Access Compliance Report

Public Rights-of-Way (Curb Ramps)

Intersection ID: 10350	Main Street: BANCROFT_ST	Cross Street: KESWICK_AV	Location:	N
ADA ID: 19EB50FC9B4A	Ramp Type: PerpDiag	Initial Pass/Fail: Fail	Overall Compliance: No	Severity Score: 25

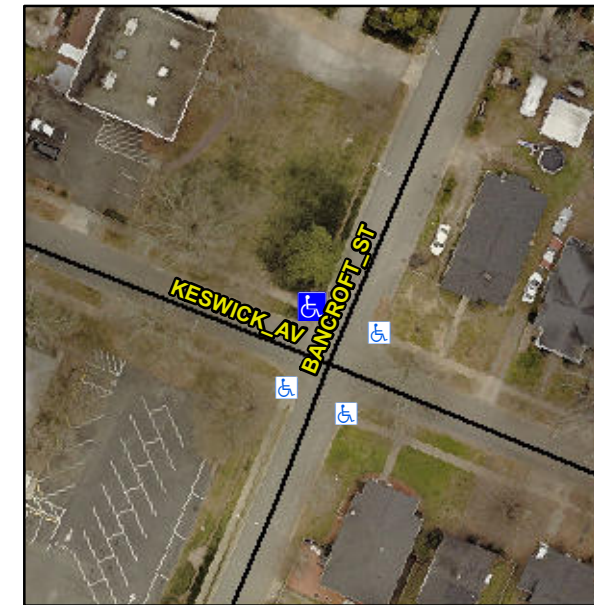
Compliance	Description	Data	Compliance	Description	Data
N/A	Ramp Length (in)	66.0	No	Ramp Slope (%)	13.0
Yes	Ramp Width (in)	57.5	Yes	Ramp XSlope (%)	0.8
N/A	Flare Type LT	N/A	N/A	Flare Type RT	N/A
N/A	Flare Slope LT (%)	N/A	N/A	Flare Slope RT (%)	N/A
N/A	Flare Traversable LT?	N/A	N/A	Flare Traversable RT?	N/A
N/A	Landing Length (in)	N/A	N/A	DWS Provided?	N/A
N/A	Landing Width (in)	N/A	N/A	DWS Contrast?	N/A
N/A	Landing Slope (%)	N/A	N/A	DWS Length (in)	N/A
N/A	Landing X Slope (%)	N/A	N/A	DWS Full Width?	N/A
N/A	Landing Curb? (Y/N)	N/A	N/A	DWS Offset (in)	N/A
N/A	Shared Landing?	N/A			
N/A	Gutter Ponding?	Yes	N/A	Gutter Slope (%)	N/A
N/A	Gutter Lip Ht (in)	N/A	N/A	Gutter X Slope (%)	N/A
N/A	Painted X Walk1?	No	N/A	Painted X Walk2?	No
	X Walk 1 Direction	To SW		X Walk 2 Direction	To SE
N/A	X Walk 1 Width (in)	N/A	N/A	X Walk 2 Width (in)	N/A
	X Walk 1 Slope (%)	2.3		X Walk 2 Slope (%)	1.0
	X Walk 1 X Slope (%)	1.3		X Walk 2 X Slope (%)	0.8

Remove & Replace Curb Ramp With Two New Directional Ramps or Equivalent.

R304.2.2
